ADDRESS . . : 153 DUCK LN
CONTRACTOR : DUSTIN BLACKWELL, INC
OWNER . . . : FLAHERTY PAUL & JENNIFER #421
PARCEL . . . : 03-9587-01- -0156- - -
APPL NUMBER: 08-50019474 CP NEW RESIDENTIAL (SFD)
DIRECTIONS : BUFFALO LAKES #421-27W TO BUFFALO LAKE
RD TO VIC KEITH RD TO DUCK LN.JD

Subject: Structural evaluation of timber pile driving records.
Reference: 153 Duck Lane Lillington, Lot 421 Buffalo Lakes, Harnett Co., North Carolina.

Project: Buffalo Lakes – 153 Duck Lane
Location: Harnett County, North Carolina
Client: Tri City Contractors

<p>TOWER ENGINEERING PROFESSIONALS</p>	PROJECT	Buffalo Lakes - 153 Duck Lane	FIGURE NO.	1	JOB NO.	090001.02
	TITLE	Basement Slab Surge Stabilization + French Drain Details		SCALE	N.T.S.	
				BY	C. Bauer	
				DATE	3-4-09

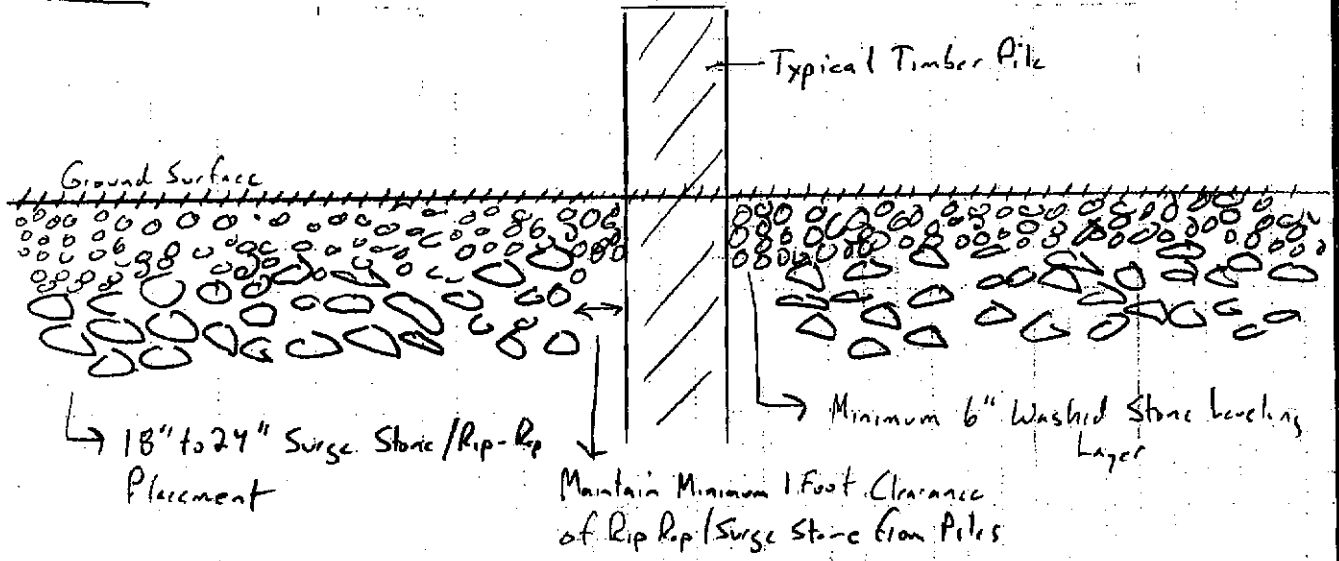
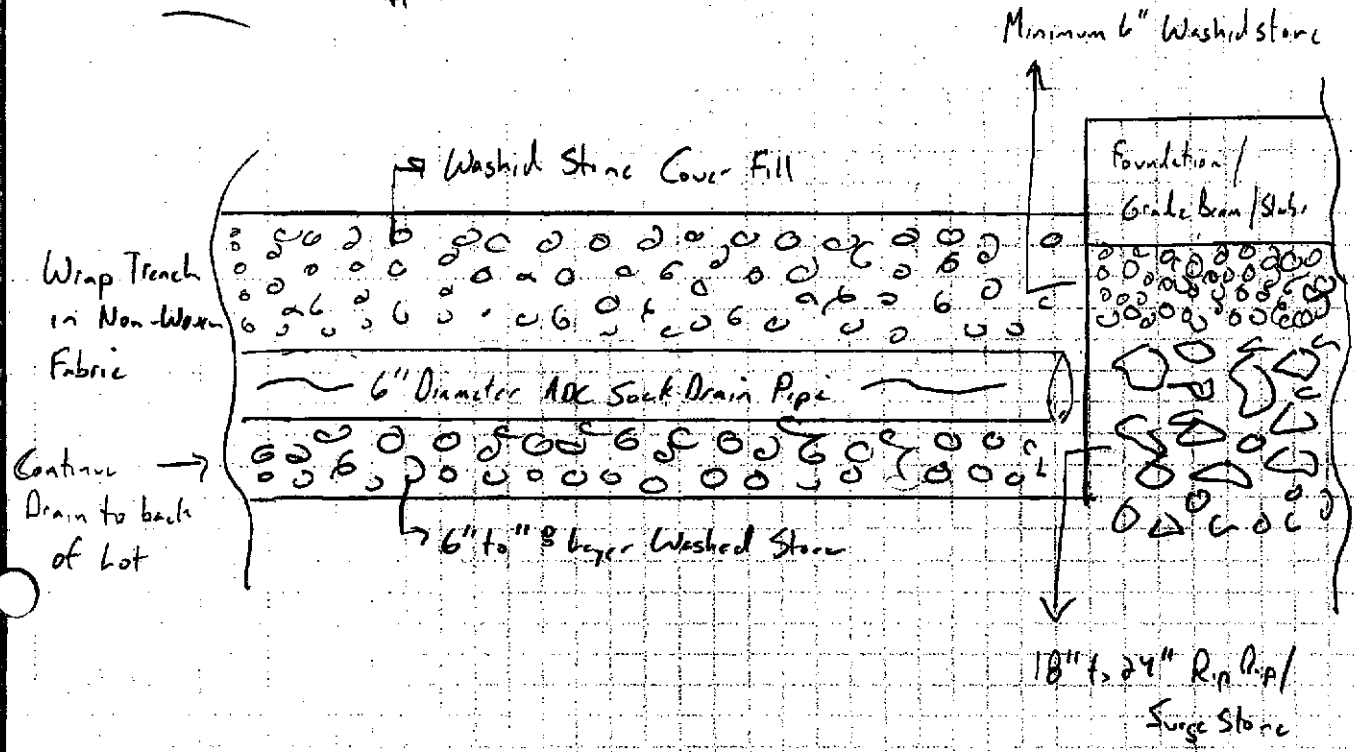
1. Remove all soils that have been piled within the basement footprint and that have sloughed from the sidewalls of the excavation to create a level basement soil subgrade. Caution should be exercised to not disturb the existing timber piles.
2. Place thin layers of rip rap (8 to 10 inches in diameter or less) or large surge stone across the basement soil subgrade. Stone should be “mashed” or “pushed” into the subgrade utilizing the flat end of a trackhoe bucket. This process should be repeated across the entire basement subgrade until approximately 18 to 24 inches of stone have been “mashed” into the subgrade. Caution should be taken around the existing piles – stone placement should be kept away from existing piles a minimum of 1 foot. Please see the

attached figure for a cross section of stone placement.

5. TEP also recommends french drain installation to alleviate potential water build-up under the proposed basement slab. Drains can be installed from the back two corners of the basement within the top foot of the rip-rap/washed stone layer and run to the back of the lot. A minimum of 2% slope should be maintained to the back of the drain trench. The trench should be approximately 18 inches by 18 inches. The trench should be lined with non-woven geotextile fabric with overlay at the top to cover the top of the trench upon completion of stone and drain pipe placement. A 6 to 8 inch layer of washed stone should be placed at the bottom of the trench. A 6 inch diameter ADC sock drain pipe should be placed in the center of the trench. The trench should be backfilled with washed stone to the top and the fabric lapped over the stone. Soil backfill can then be placed over the drain. Please see the attached figure for the drain detail.

3. A layer of washed stone (57 stone or equivalent) should be placed across the rip rap layer to design elevation for concrete slab placement. TEP recommends a minimum of 6 inches of washed stone be placed. Foundations/grade beams can be hand excavated through the washed stone layer if necessary.

4. TEP recommends a vapor barrier be placed on the washed stone prior to concrete placement. TEP also recommends #4 bars 24 inches on center each way be placed for the basement slab.
